INTERNATIONAL CODE COUNCIL
2012-2014 CODE DEVELOPMENT CYCLE
Group B (2013)

2013 PUBLIC COMMENT AGENDA
DISCUSSION GUIDE
&
TECHNICAL UPDATES

2013 ICC CODE DEVELOPMENT CYCLE
TECHNICAL UPDATES TO THE 2013 PUBLIC COMMENT
AGENDA FOR THE PROPOSED CHANGES
TO THE:

FIGURE R507.2.3(2)

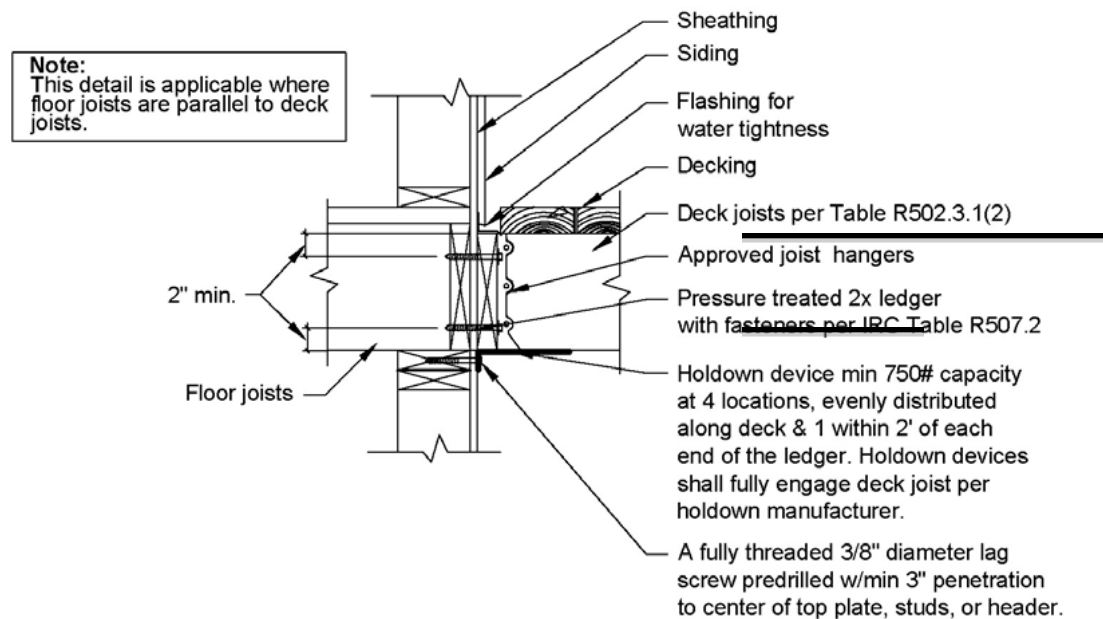
Modify the proposal as follows:

R507.2.3 Deck lateral load connection. The lateral load connection required by Section R507.1 shall be permitted to be in accordance with Figures R507.2.3(1) or R507.2.3(2). Where the lateral load connection is provided in accordance with Figure 507.2.3(1), hold-down tension devices shall be installed in not less than two locations per deck, and each device shall have an allowable stress design capacity of not less than 1500 pounds (6672 N). Where the lateral load connections is provided in accordance with Figure R507.2.3(2), the hold-down tension devices shall be installed in not less than 4 locations per deck, and each device shall have an allowable stress design capacity of not less than 750 pounds (3336 N).

Commenter's Reason: Table R502.3.1(2) does not account for wet-service use and treated or incised lumber, so its reference should be struck. If RB-264 or RB-268 were approved this could reference those appropriate span tables for deck joists. Section R507.2 allows for "approved decay resistant species" for ledgers. This detail should not preclude the use of these materials through its reference to "pressure treated 2x ledger", therefore it should be struck.

**FIGURE R507.54
TYPICAL DECK JOIST SPANS**

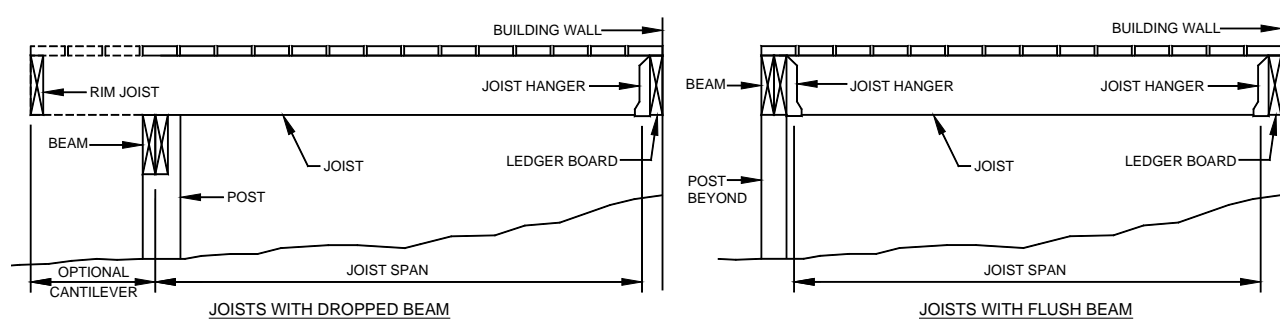
R507.54 Allowable deck joist spans. Spans for wood deck joists, as shown in Figure R507.54, shall be in accordance with Table R507.54. Deck joists shall be permitted to cantilever a maximum of one-fourth of the actual joist span.

Commenter’s Reason: There are no provisions for building a wood-framed, exterior deck under the prescriptive provisions of the existing IRC. Decks have notoriously never been address comprehensively in any building standard in our country, and therefore there are a great variety of construction methods that have long been in practice. An informal and open group of professionals and organizations have been working together to recognize this variety and develop well-rounded provisions suitable for the IRC. The provisions proposed in the original RB264-13 represented what could generally be agreed upon by the majority, however, testimony during the hearings on this and other deck-related proposals drew doubt from the committee that industry-wide agreement had been met.

FIGURE R507.65
TYPICAL DECK BEAM SPANS

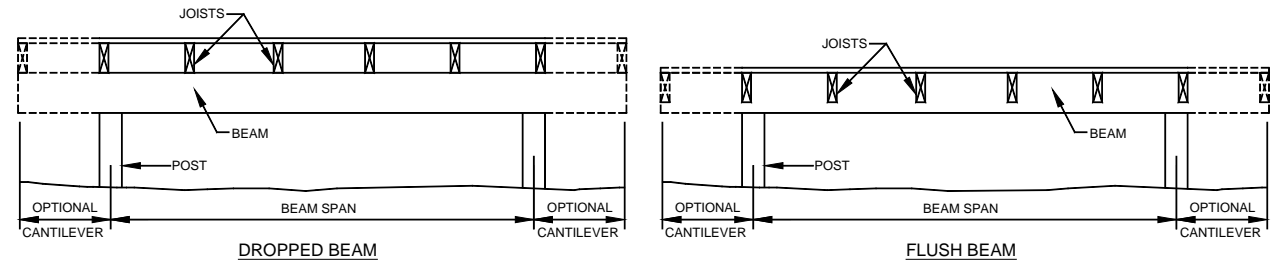
R507.65 Deck Beams. Spans for deck beams, as shown in Figure R507.65, shall be in accordance with Table R507.65. Beam plies shall be fastened in accordance with Table R602.3(1), with two rows of 10d (3" x 0.128") threaded nails minimum at 16 inches (406 mm) on center along each edge. Beams shall be permitted to cantilever at each end up to one-fourth of the actual beam span. Splices of multi-span beams shall be located at interior post locations.

**FIGURE R507.8.1
DECK BEAM TO DECK POST**

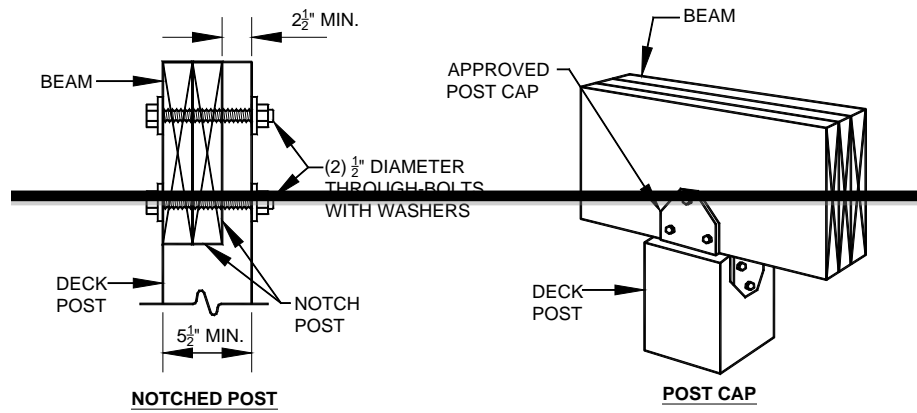
R507.8.1 Deck post to deck beam. Deck beams shall be attached to deck posts in accordance with Figure R507.8.1. Post-to-beam connections shall be constructed to resist lateral displacement. Manufactured post-to-beam connectors shall be sized for the post and beam sizes. All bolts shall have washers under the head and nut.

**FIGURE R507.8.2
TYPICAL DECK POSTS TO DECK FOOTINGS**

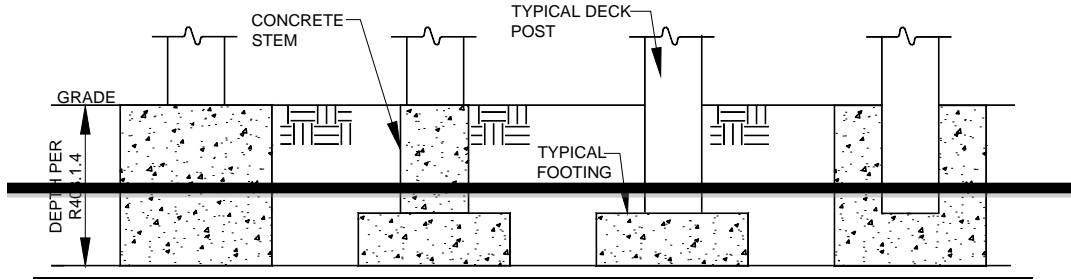
R507.8.2 Deck post to deck footing. Posts shall bear on footings in accordance with Section R403 and Figure R507.8.2.

**FIGURE R507.5
TYPICAL DECK JOIST SPANS**

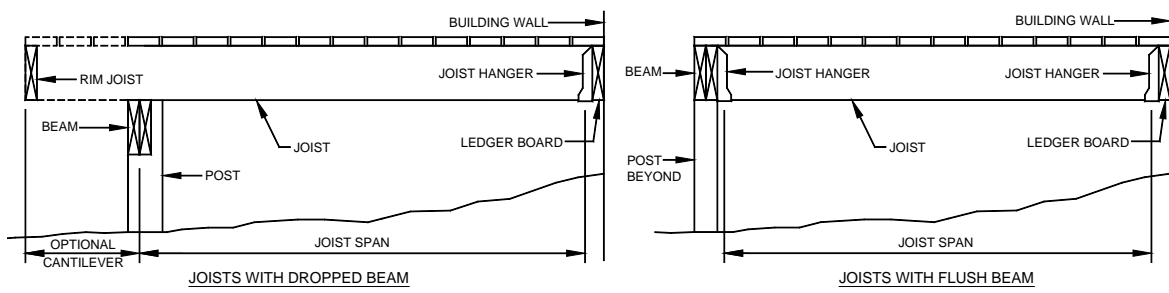
R507.5 Allowable Deck joist spans. Maximum allowable spans for wood deck joists, as shown in Figure R507.5, shall be in accordance with Table R507.5. Deck joist shall be permitted to cantilever a maximum of one-fourth of the actual, adjacent joist span.

RB264-13, in this public comment, has been expanded and re-written to recognize further consensus from the discussion group, to better present code provisions, and to address opposition testimony from the committee hearings.

**FIGURE R507.6
TYPICAL DECK BEAM SPANS
TABLE R507.6
DECK BEAM SPAN LENGTHS (ft.-in.)^{a, b}**

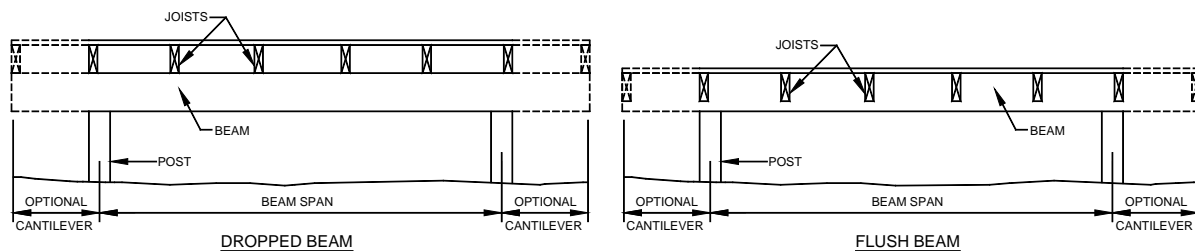
R507.6 Deck Beams. Maximum allowable spans for wood deck beams, as shown in Figure R507.6, shall be in accordance with Table R507.6. Beam plies shall be fastened with two rows of 10d (3" x 0.128") threaded nails minimum at 16 inches (406 mm) on center along each edge. Beams shall be permitted to cantilever at each end up to one-fourth of the actual beam span. Splices of multi-span beams shall be located at interior post locations.

**FIGURE R507.8.2
TYPICAL DECK POSTS TO DECK FOOTINGS**

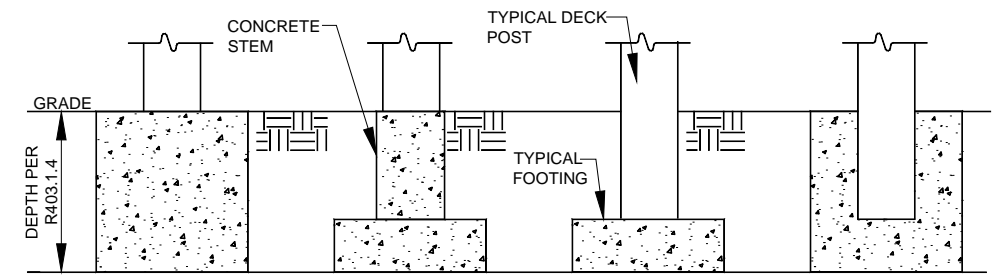
R507.8.2 Deck post to deck footing. Posts shall bear on footings in accordance with Section R403 and Figure R507.8.2. Posts shall be restrained to prevent lateral displacement at the bottom support. Such lateral restraint shall be provided by manufactured connectors installed in accordance with Section R507 and the manufacturers' installation instructions or a minimum post embedment of 12-inches in surrounding soils or concrete piers.

The post-sizing provisions have also been presented in table form for better presentation of the information. Concerns regarding Figure R507.8.2 and the lack of a projection of the foundations above grade level were brought up during the hearing and were recognized in this public comment. It was agreed by the proponents of this comment that foundation details are not the appropriate location for provisions regarding the decay resistance of wood members. To better clarify the relationship between the height of footing and the decay resistance of the posts, a third exception specifically addressing decks was added to the current provisions for post (column) decay resistance, R317.1.4, "Wood columns"

Photo 1. ASTM E2632 under-deck test in progress.

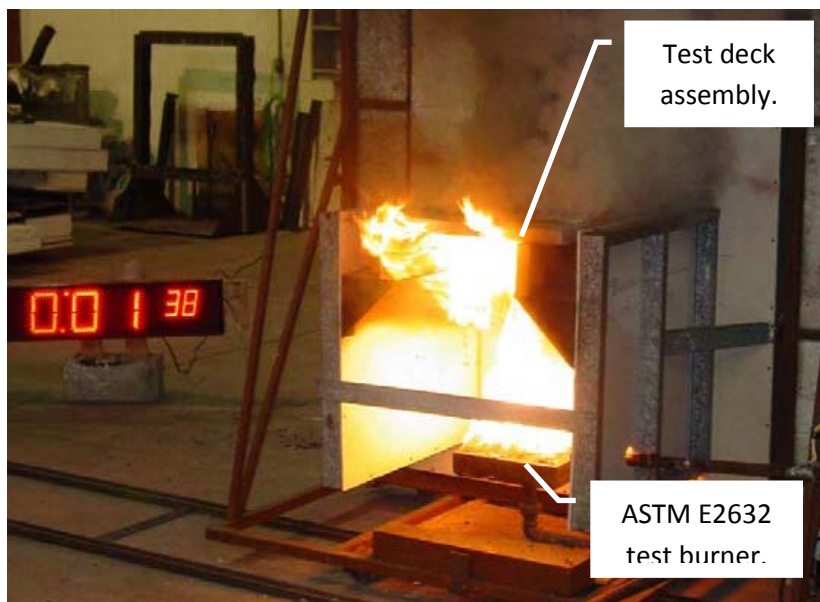
Below are pictures of the ASTM E2632 / E2632M test. Notice the configuration of this small test deck and the wall to which the deck is adjacent, simulating an actual installation of a deck attached to the structure.

Photo 4. Test deck assembly ASTM E2632 fire test failure.

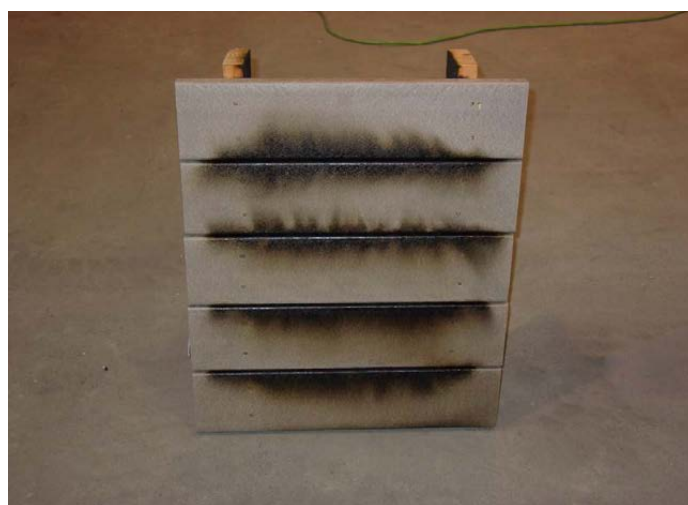
During the ASTM E2632 fire test 40-minute observation period, this test deck assembly had a peak heat release rate in excess of 25 kW/ft². This decking material would not meet the criteria for use in a WUI area as it exceeded the proposed maximum peak heat release rate.
